Final Environmental Impact Report

# Vallco Special Area Specific Plan

SCH# 2018022021

August 2018

Figure 8: Vallco Specific Plan Process Alternatives to Date (self)

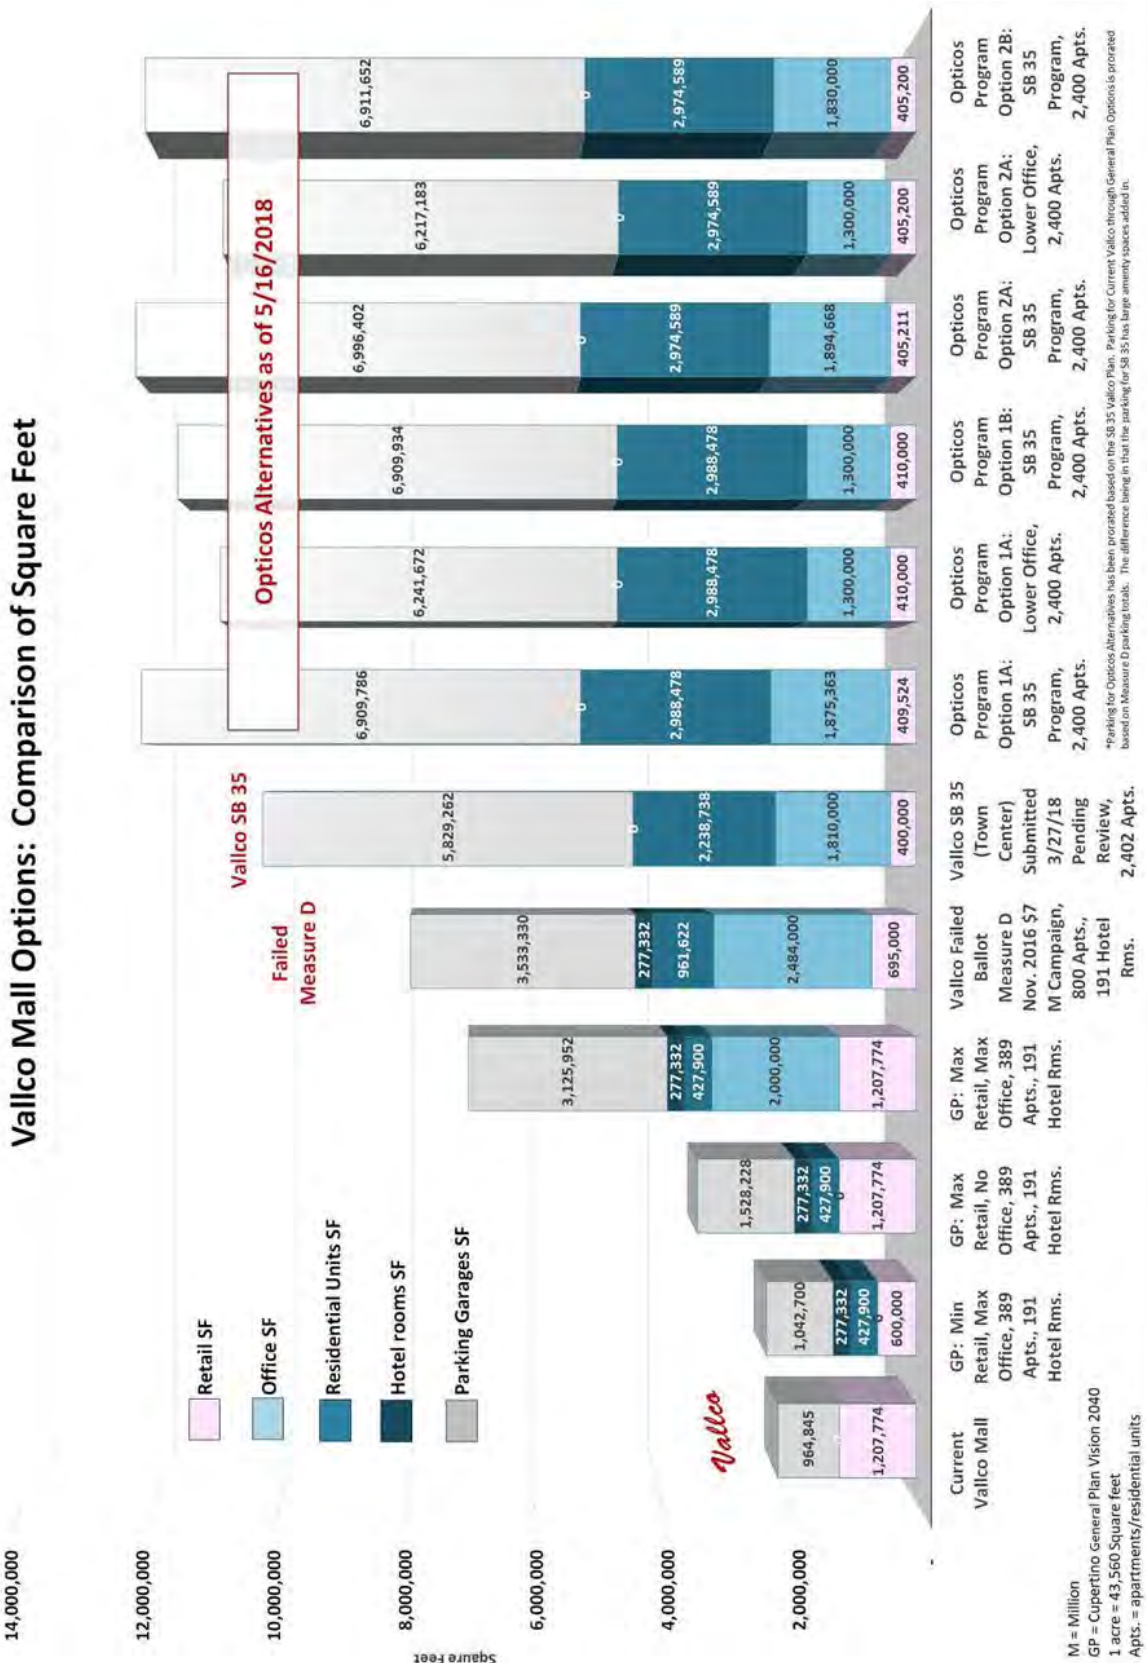
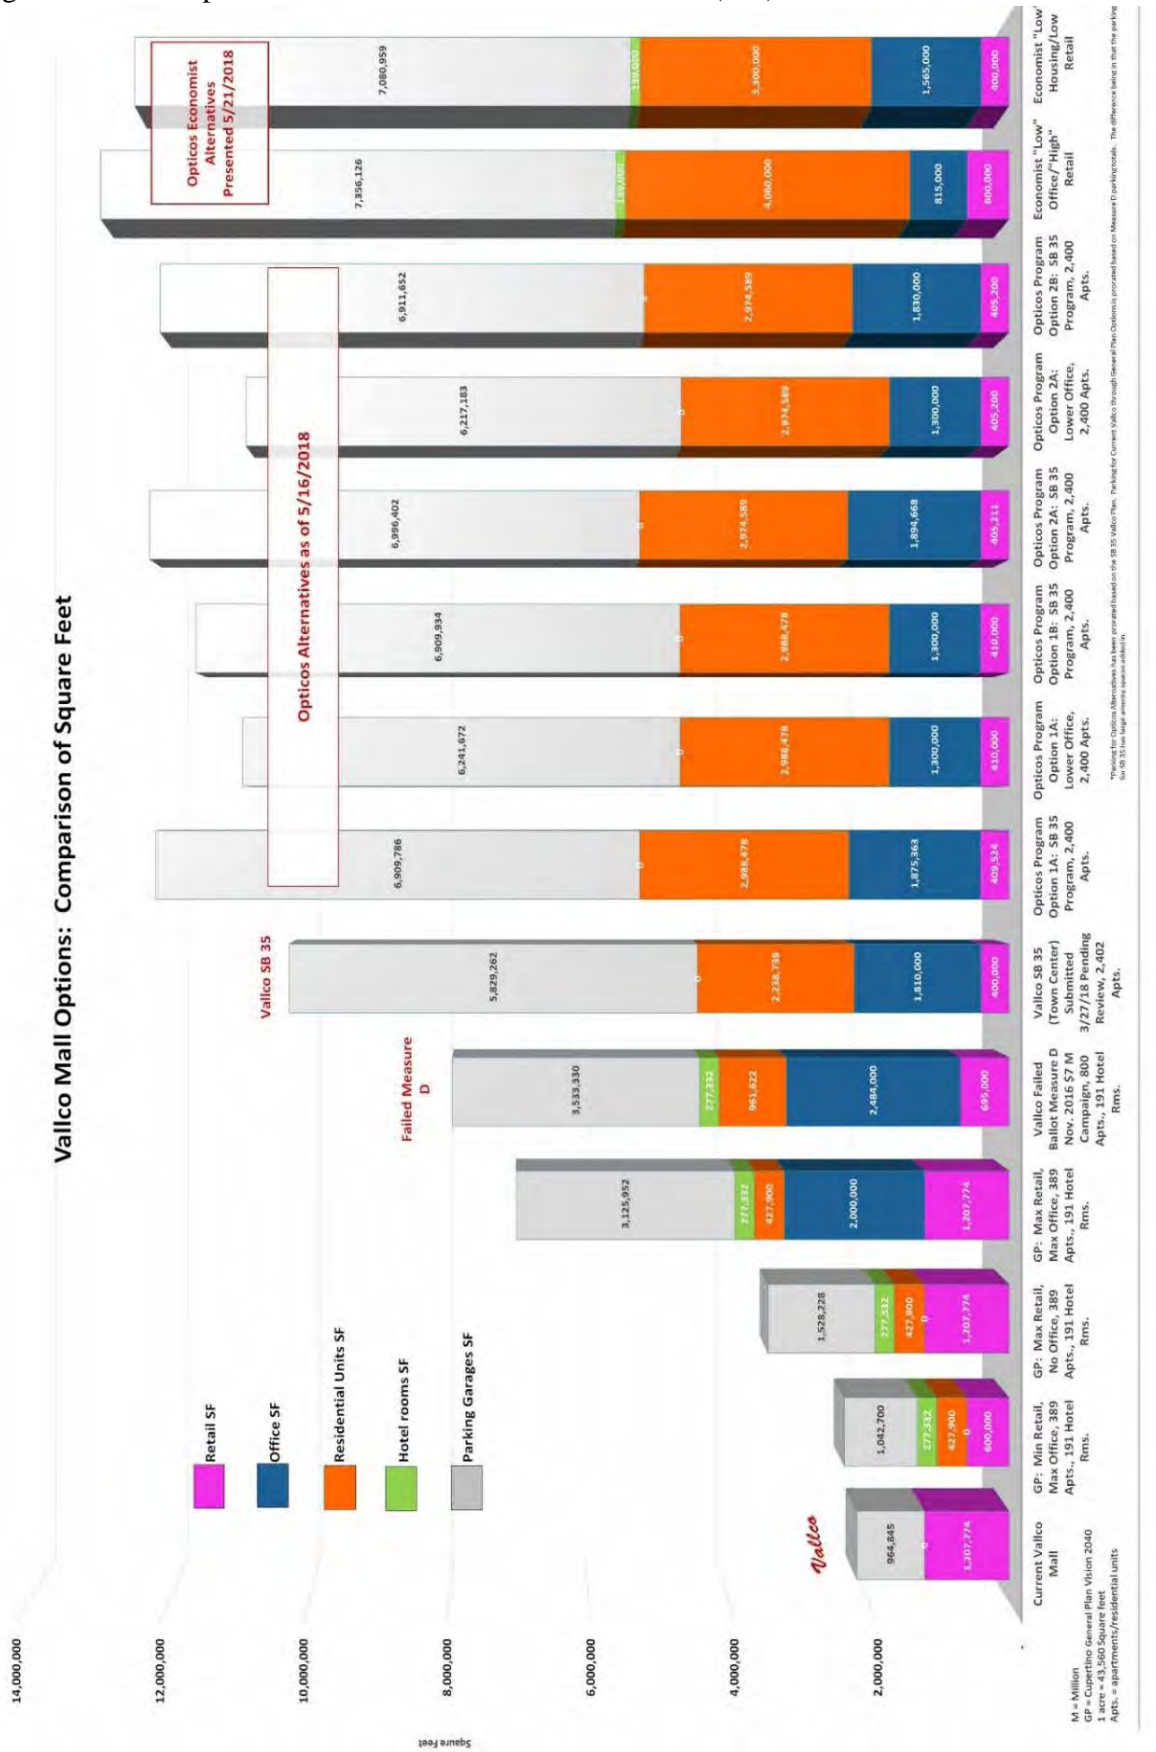
Figure 7: Vallco Project Alternatives after Charrette #1 (self)

**Response G.21:** Refer to Section 5.2 Response II.E.19.

Figure 25: AQI from BAAQMD

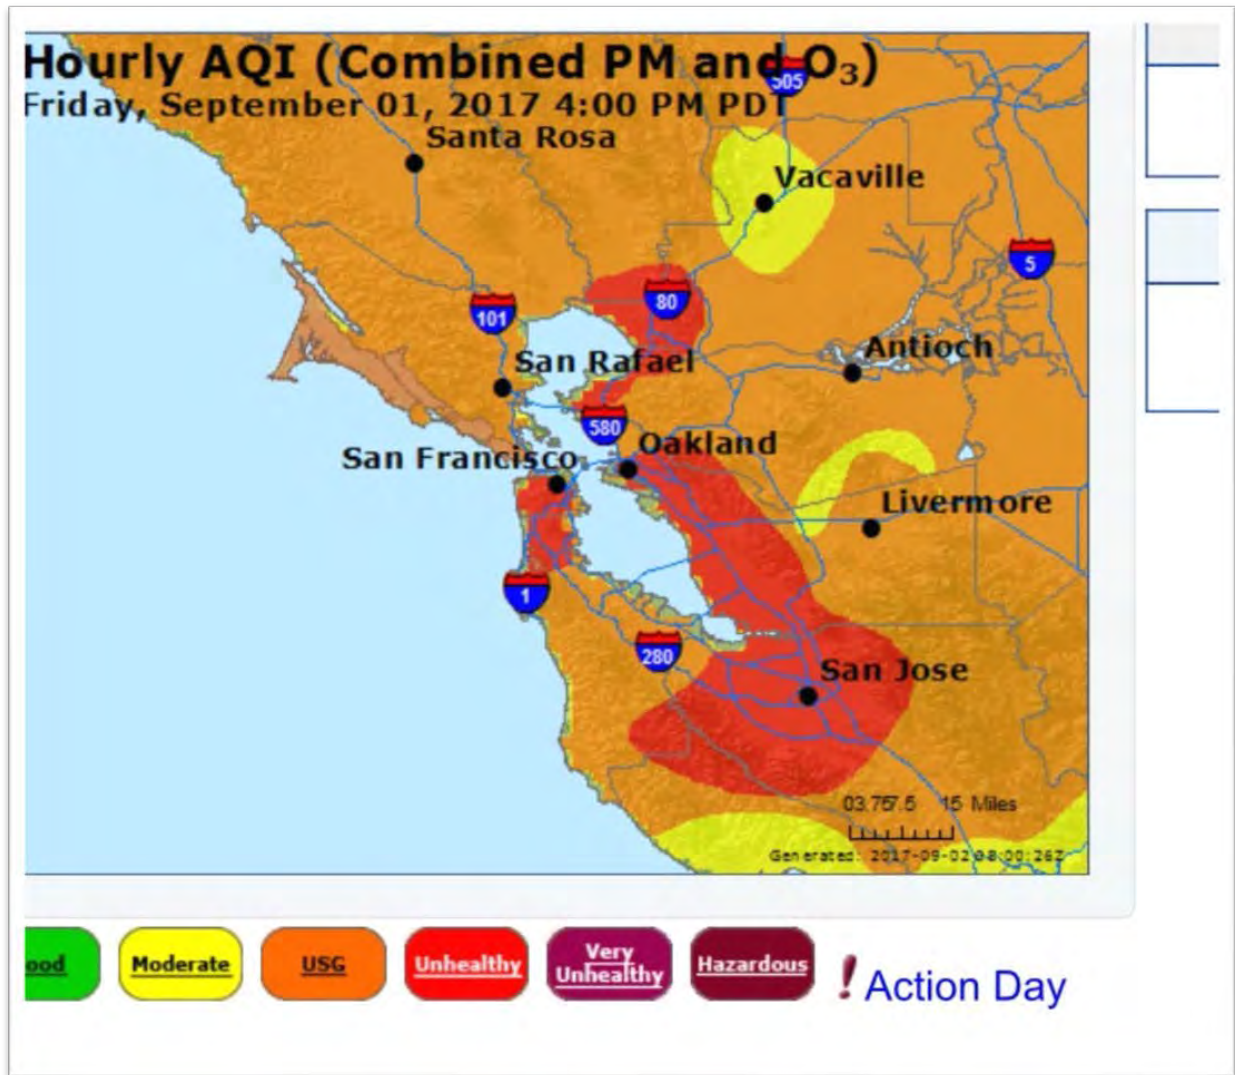
The cancer risk assessment is based on erroneous traffic studies and the air quality monitoring stations had old data from 2013 and/or were too far away to use data. The cancer risk needs to be recalculated. The amount of exposure time should reflect seniors not leaving the project area. The baseline air quality monitoring must be taken over an extended period with particular attention paid to the summer months when Ozone levels increase. Here is an example day when children would be playing outdoors, Ozone was the primary pollutant. Note these are regional amounts, and the increases along the freeways are not shown:

**Response G.55:** Refer to Section 5.2 Response II.E.53.

Figure 42: Opticos Charrette #2

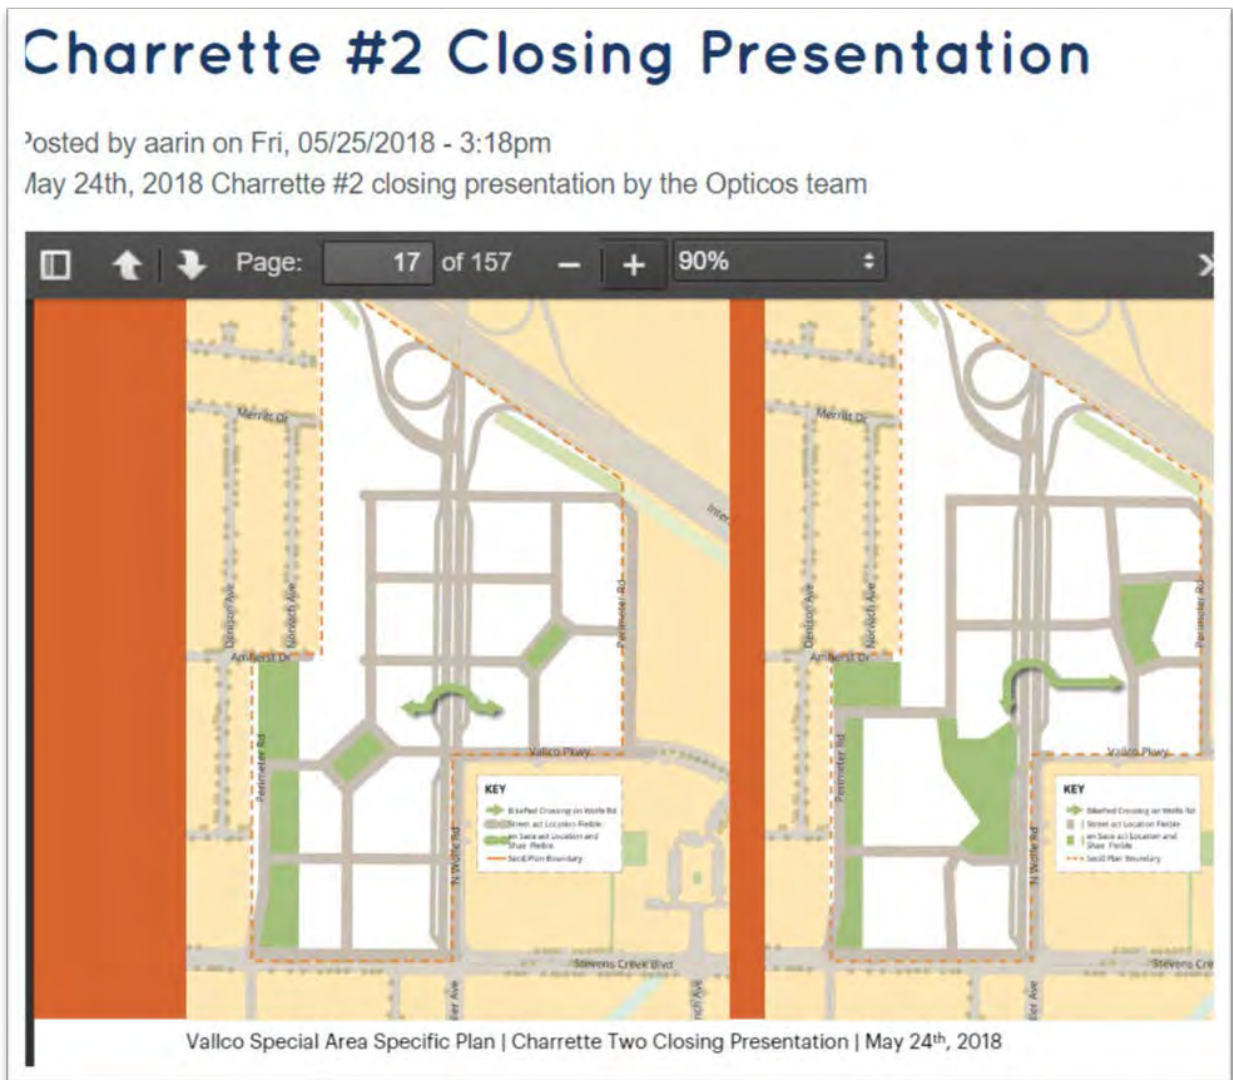
Charrette #2 Closing Presentation shows parks adjacent to back yards of single family residences. This may, combined with Perimeter Rd. noise exceed Municipal Code permissible sound levels. The DEIR does not adequately address this.

**Response G.107:** Refer to Section 5.2 Response II.E.105.

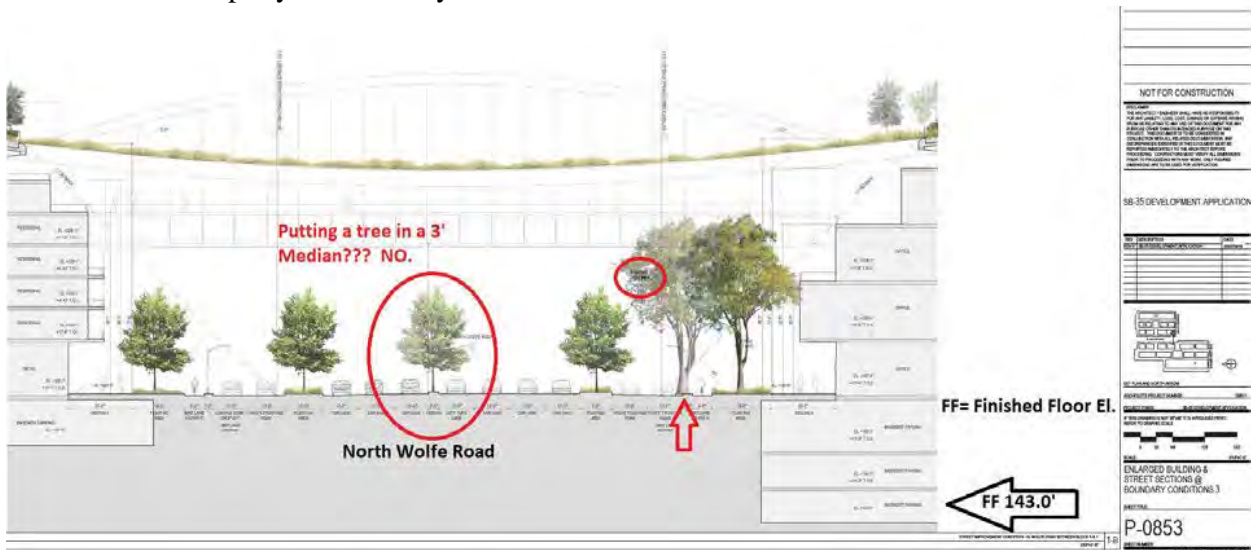
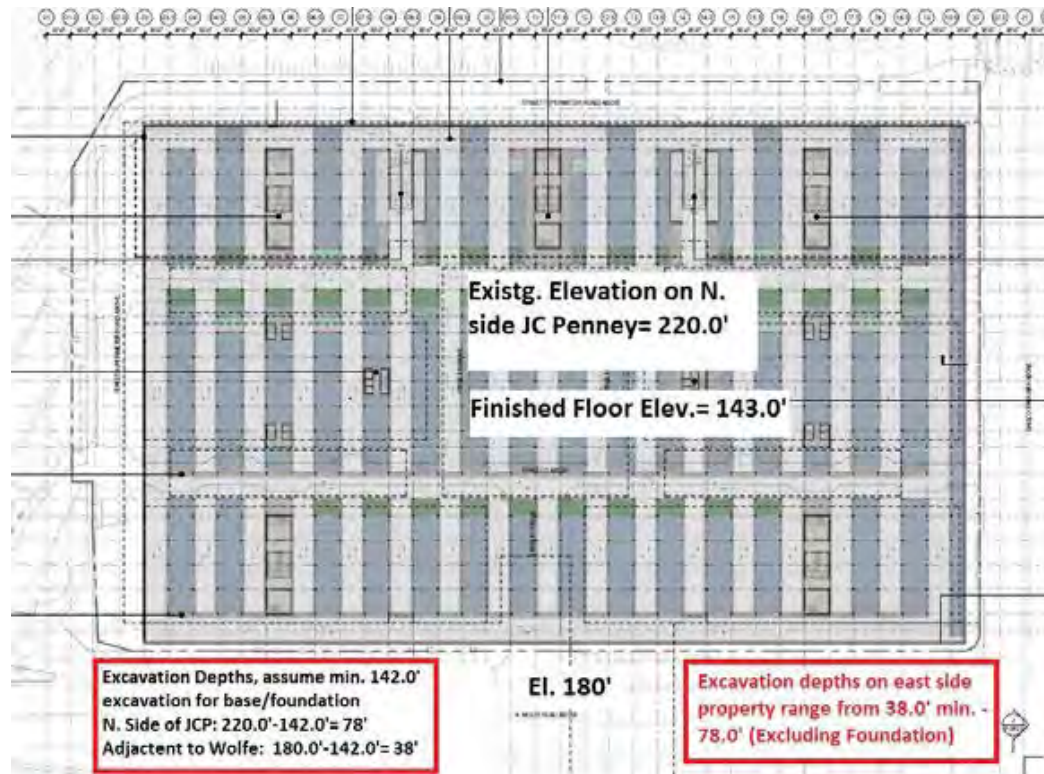
Architectural Plans Part 3, P-0853 show the finished floor elevation at 143.0, and there would be excavation a few feet below that level for the foundation. Let's be generous and say they only need to excavate 1' below the basement level of the garage, so the depth of excavation on the east side will be to 142.0'.

Where are the Property Lines? They do not show them.

Now, recall that the ENTIRE property will sit at one level of underground parking, they are claiming incorrectly that there will be only 20 to 30 feet of excavation for underground parking when it will be a **MINIMUM 38' to a MAXIMUM 78'**.

This has to be communicated and fixed in the DEIR.

Are you aware of these excavation depths? I am wondering if the soil excavation calculations are correct, I have seen no actual cross sections of cut and do not want to run them myself...

Figure 4: DEIR Heights

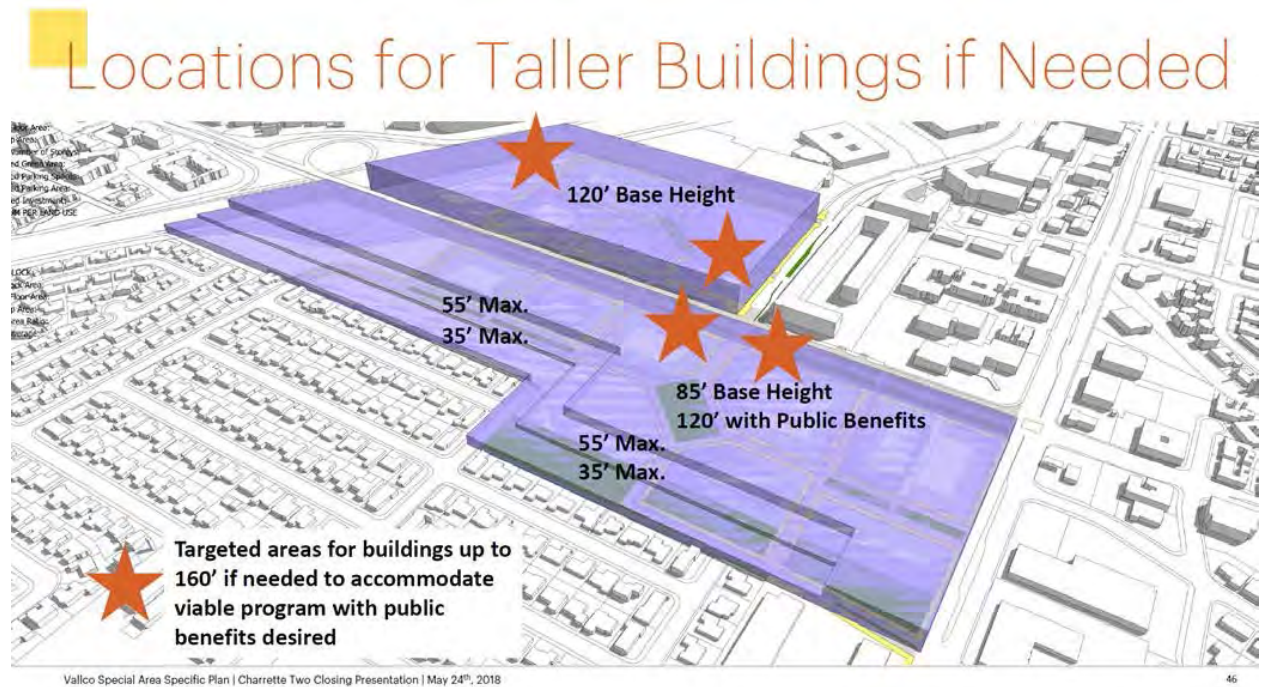
**Comment O.16:** 3. 65,000 SF of civic space, STEM lab, and 30 acre green roof were not discussed in the NOP period for Vallco. In the DEIR civic space and STEM lab are combined into the 65,000 SF. Additionally, the civic/STEM spaces are considered public benefits which would result in higher building heights if the developer includes them. This was mentioned at the Opticos Charrette #2 closing presentation, May 24, 2018:

**Response O.16:**
